RESOLUTION HOLDING HEARING ON REQUEST FROM KADING PROPERTIES, LLC. (OWNER), REPRESENTED BY KARIE RAMSEY (OFFICER), FOR REVIEW AND APPROVAL OF THE 9TH AMENDMENT TO THE MEADOWLANDS PUD CONCEPTUAL PLAN, 2100 MEADOW COURT

Communication from the City Plan and Zoning Commission advising that at their meeting held October 16, 2014, the following action was taken regarding a request from Kading Properties, LLC. (owner) represented by Karie Ramsey (officer) for review and approval of the 9th Amendment to the Meadowlands PUD Conceptual Plan on property at 2100 Meadow Court.

P.U.D. CONCEPTUAL PLAN 9TH AMENDMENT MEADOWLANDS

DRAWN BY: H.L.L.
CHECKED BY: H.L.L.
DATE: 10-28-14
JOB NO. 14090
SHEET C-1

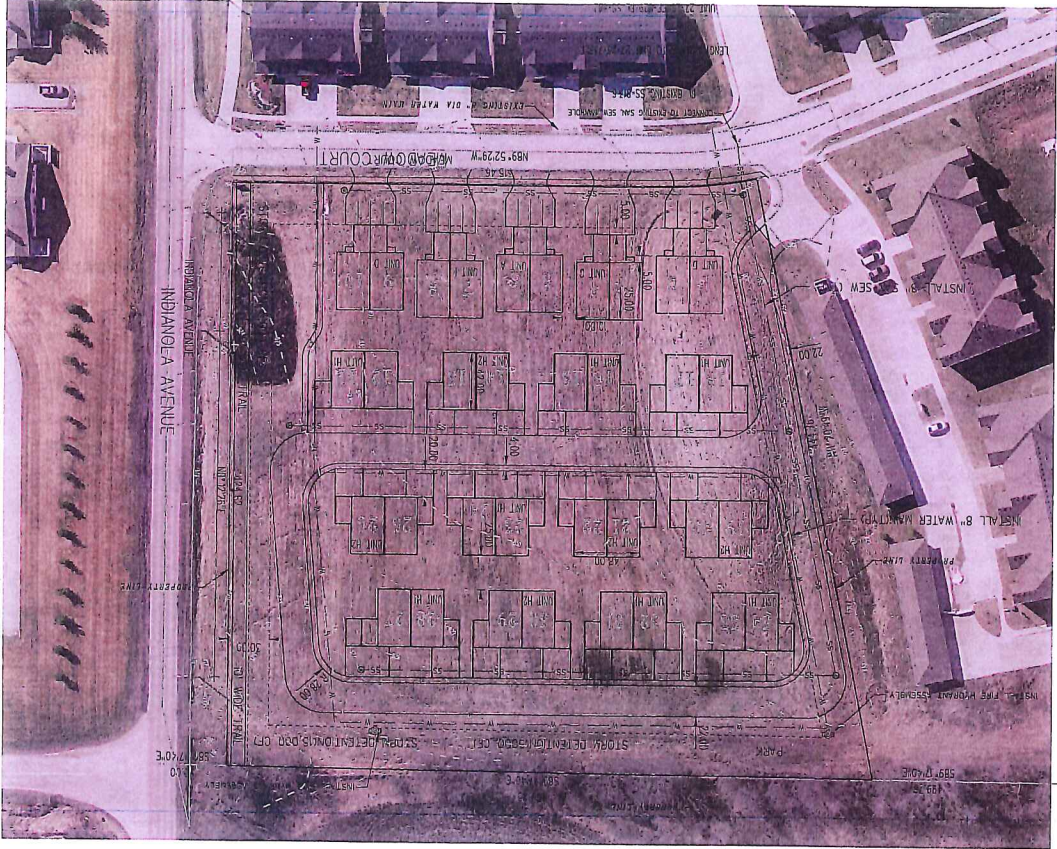
1. Conformance with all administrative review comments by the Permit and Development Center.
2. Sheets 1 and 3 shall be revised to reflect the configuration proposed on Sheet 2.

On October 9, 2014, the developer submitted a revised PUD Conceptual Plan that addresses several of staff's initial review comments. Staff notes that the layout shown on Sheet 2 is the current proposal. Therefore, Sheets 1 and 3 need to be revised to reflect this configuration.

DRAWING TITLE: SITE & LANDSCAPE PLAN

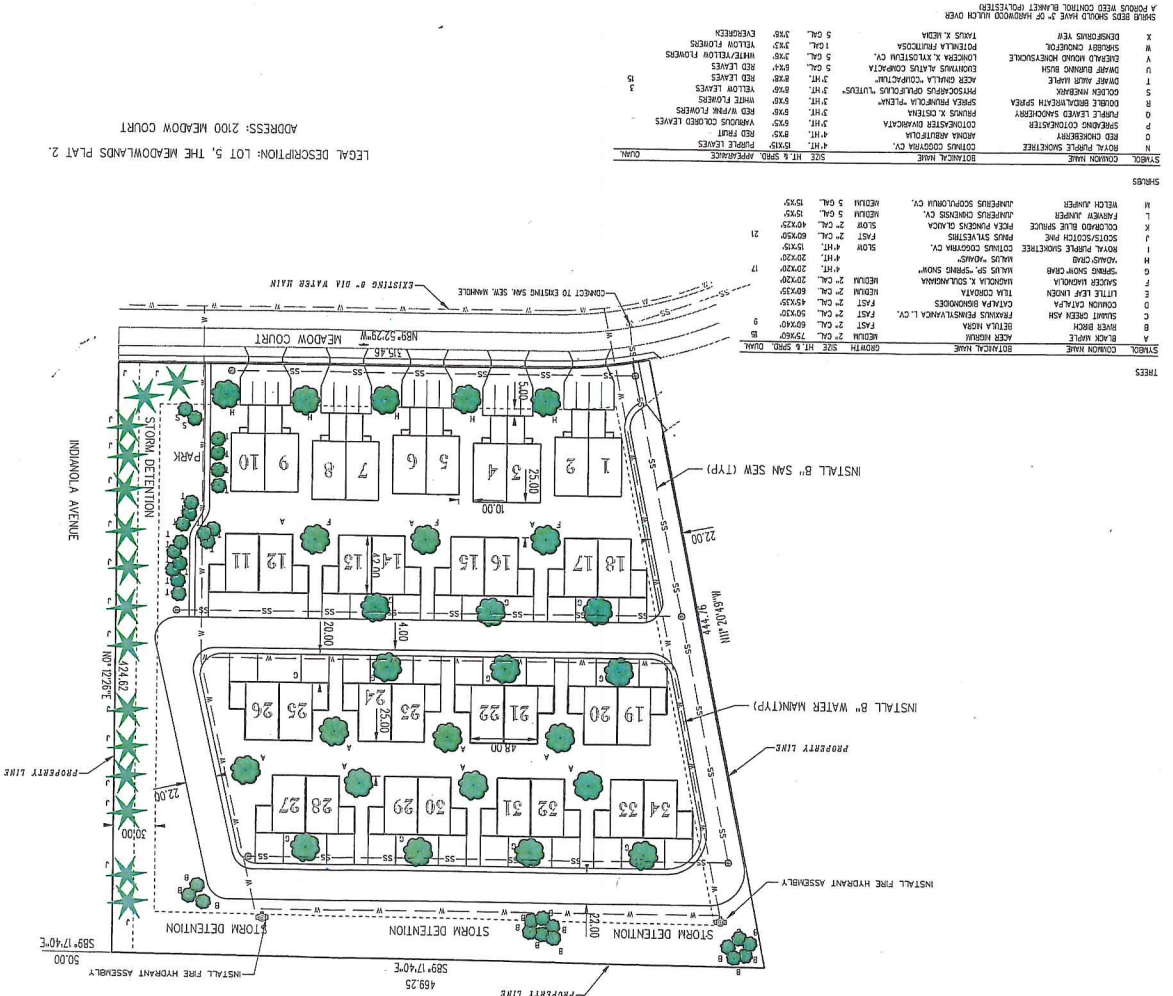
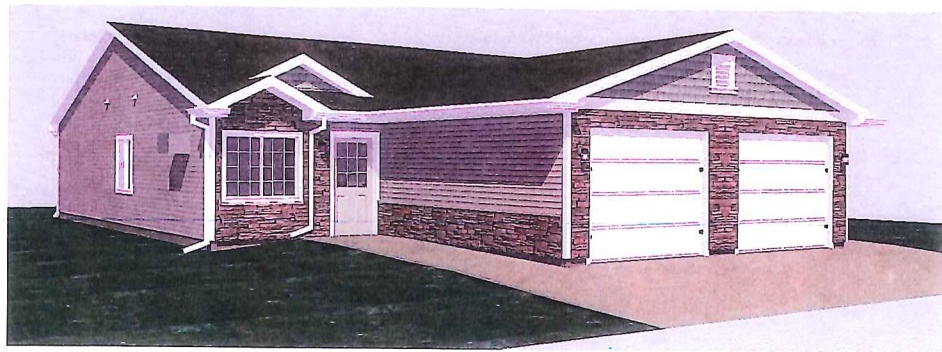
8. Provision of at least one (1) overstory tree in front of each two-family structure.
9. Provision of landscaping within the 5-foot paving setback along the west property line to the satisfaction of the City’s Planning Administrator.

10. The plantings within the northern portion of the site shall be spread out to provide an adequate buffer along the north property line to the satisfaction of the City’s Planning Administrator.

11. Relocation of the proposed private park to a more central location within the development that is more accessible and visible to residents, to the satisfaction of the City’s Planning Administrator. This may result in the loss of a dwelling unit.

4. Landscaping: The PUD Conceptual Plan demonstrates a landscaped buffer along the eastern perimeter of the site and provides a mix of overstory and ornamental trees throughout the site. Staff recommends that at least one (1) overstory tree should be provided in front of each two-family structure.

The Conceptual Plan demonstrates the private access road would be within 5 feet of the west property line. Staff recommends that some plantings be provided along the west property line to the satisfaction of the City’s Planning Administrator y.

line. Staff recommends that these trees be spread out provide an adequate buffer along the north property line to the satisfaction of the City's Planning Administrator.

Contents:
Unit Type D
Elevations

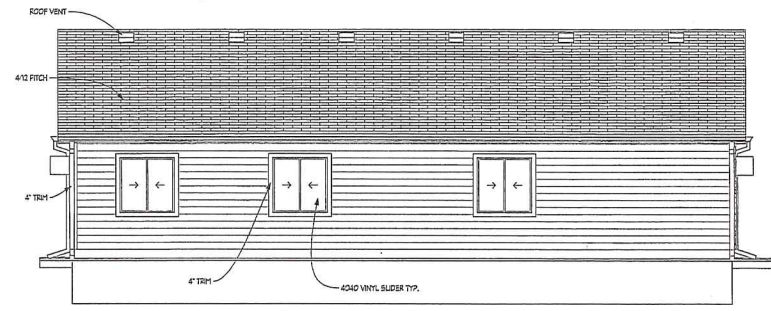
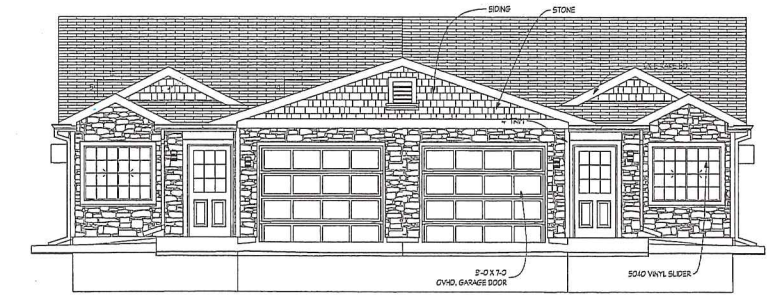
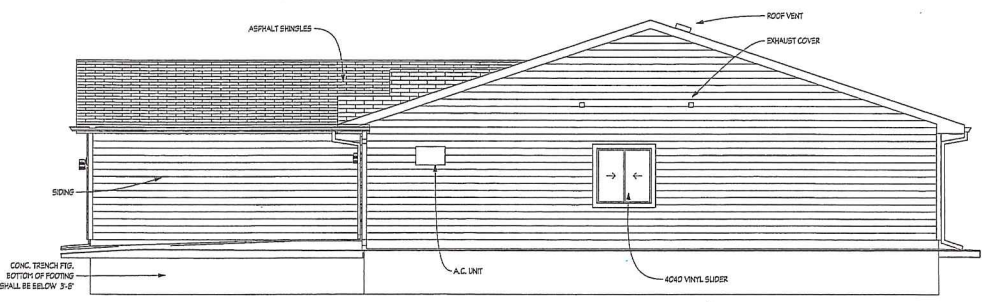
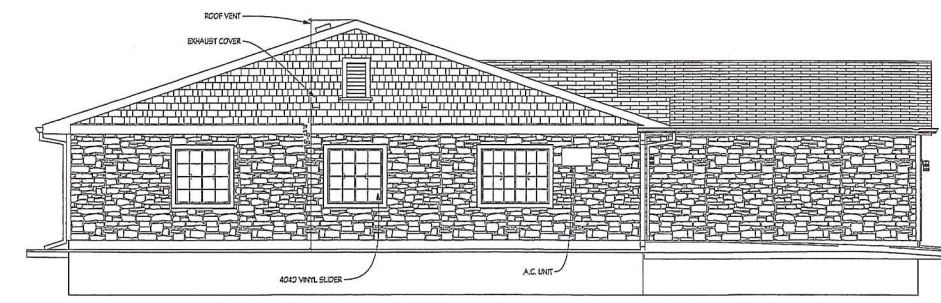
4. Provision of a sidewalk connection to the recreational trail along the east edge of the site.
5. The two building designs labeled as “Unit Type D” shall be relabeled to demonstrate the side facades facing external to the site shall consist of stone siding.

The five (5) two-family structures fronting Meadow Court would be differentiated by a mix of four (4) façade types that include varying amounts of stone material, horizontal lap siding, and shake-pattern siding. One of the types includes a front porch feature. The buildings on each end would be a “Unit D”, which includes stone on the most visible sides. Staff notes that the two details for this units are both labeled “Unit Type D”, so they should be revised to “Unit Type D-1” and “Unit Type D-2” to more clearly represent the intent.

Front Elev H-2
SCALE: 1/4" = 1'-0"

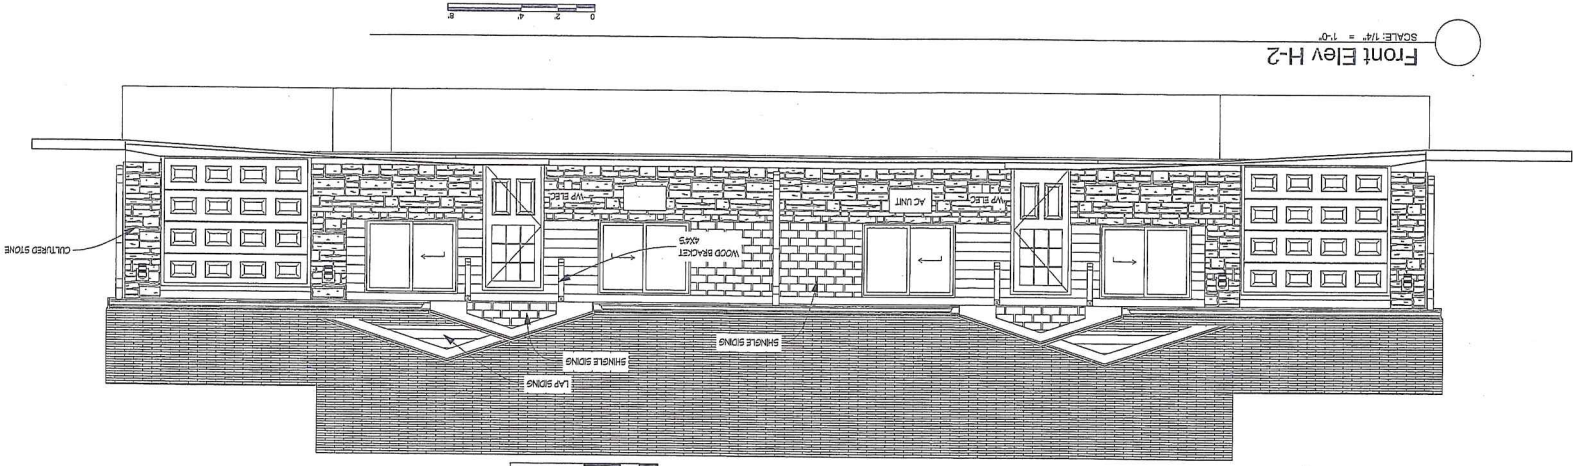
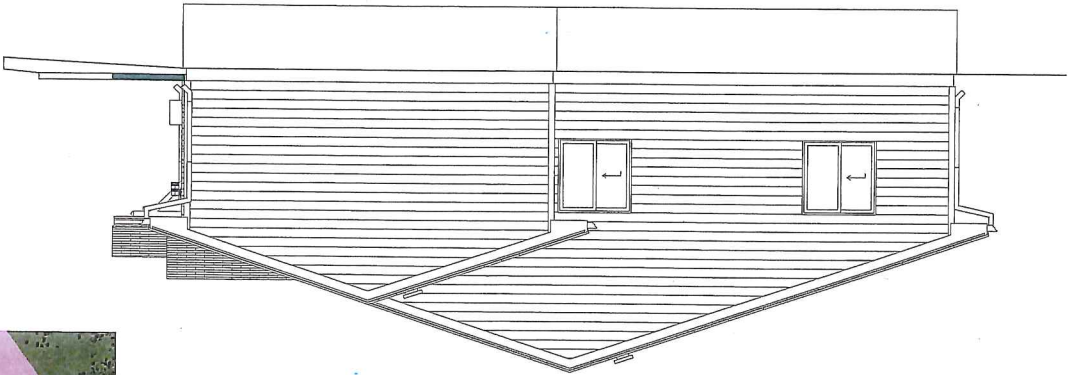
6. The building designs labeled “Option H” and “Option H-2” shall be revised to include a stone wainscot on the highly visible side facades of the furthest east and furthest west units.

The twelve (12) two-family structures fronting the private access road would all be one of two designs that are differentiated by varying amounts of stone material, horizontal lap siding, and shake-pattern siding. Staff recommends that the highly visible side facades of the furthest east and furthest west units include a stone wainscot.
